# TANY 24-34B / D215005

Replacement of Meadow Hill Road Bridge over I-87, NYS Thruway at MP 60.95 in Orange County

# **QUESTIONS AND ANSWERS**

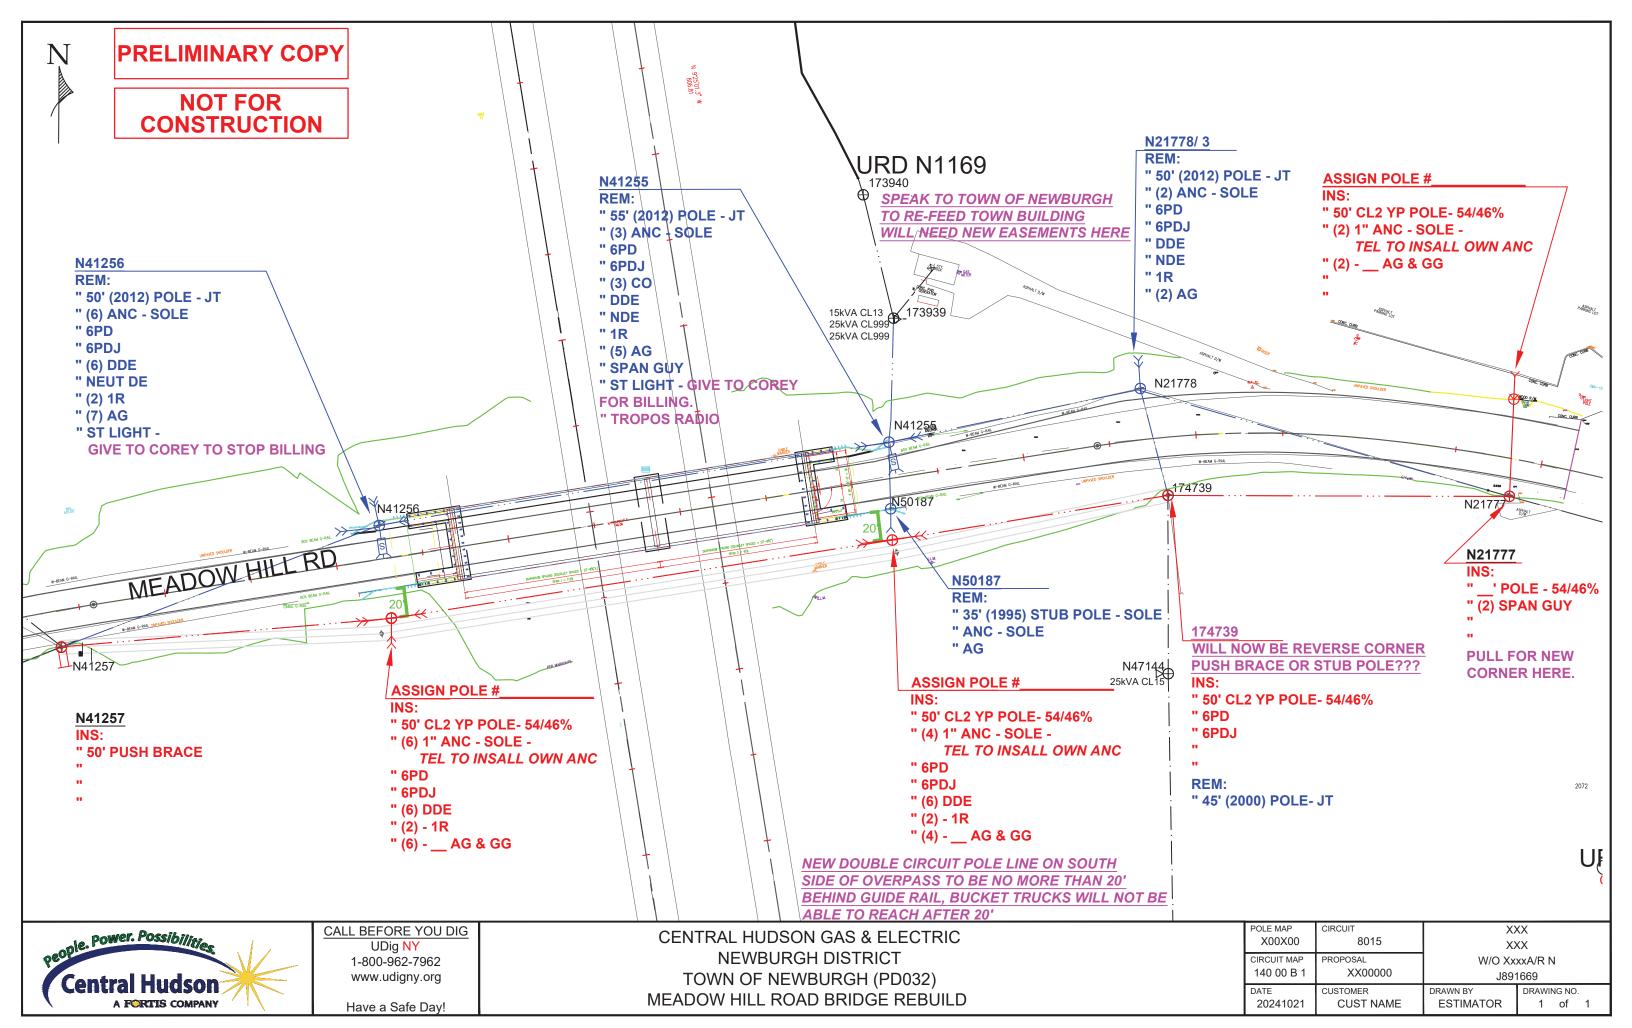
- Q5. Can the utility relocation plan and schedule for the overhead utility please be provided?
- A5. The preliminary utility relocation plan from Central Hudson is attached. All work to relocate the utilities and poles is scheduled to be completed by March 31, 2025.

- Q6. As per drawing GNP-1, it is indicated that the existing utility pole will be relocated by the utility owner. Could you please provide details regarding the relocation of the overhead cables, including the new location and whether they will remain overhead or be relocated underground? Also, could you please share the anticipated timeline for completing this work?
